Technical Service Bulletin

**CREAKING NOISE FROM FRONT SHOCK ABSORBER WHEN GOING
OVER BUMPS**

Bulletin No.: 02-005/19

Last Issued: 05/01/2019

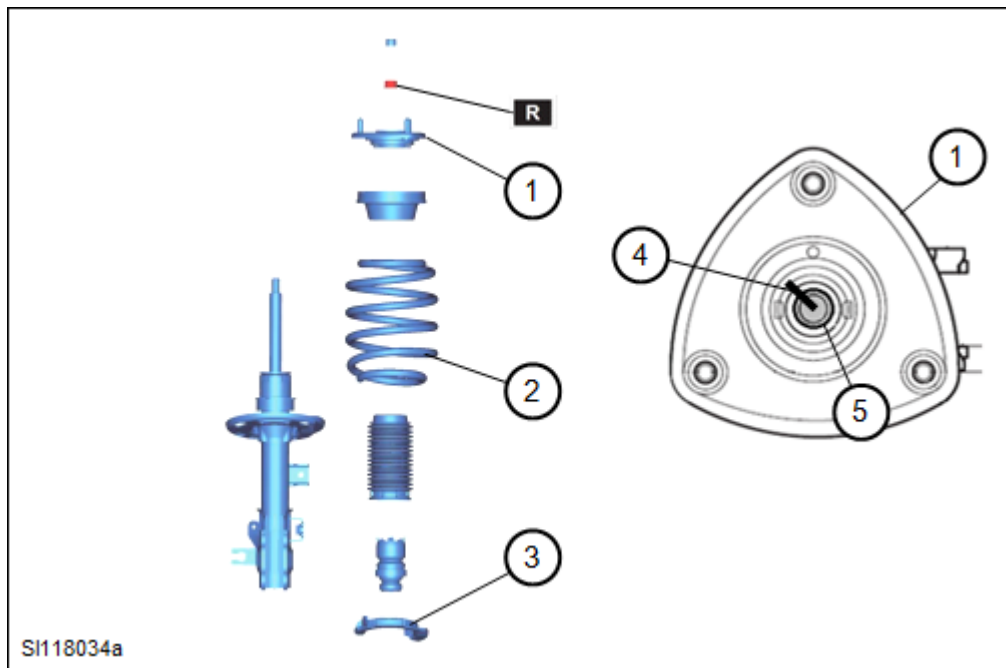
Some vehicles may experience a creaking noise from the front shock absorber when going over bumps. Upon inspection, the coil spring is found to be broken at the lower part without any trace of an accident. It may be found during maintenance or service opportunity without customer complaints. Mud and sand caught between the coil spring and the lower spring seat causes paint damage on the coil spring, resulting in rust holes and uneven force application. To correct this issue, the shape of the lower spring seat has been modified.

1. Verify customer concern.
2. Replace the broken coil spring (2) with a new one and the affected side spring seat (3) with a modified one according to the instruction on MGSS (FRONT SHOCK ABSORBER AND COIL SPRING DISASSEMBLY/ASSEMBLY).

Put a position mark (4) on the mounting rubber (1) and piston rod (5) before removing the mounting rubber from the shock absorber assembly so the mounting rubber can be installed back in the original position. If this has been done, it is not necessary to adjust the front wheel alignment because the front shock absorber and the mounting rubber are not replaced.
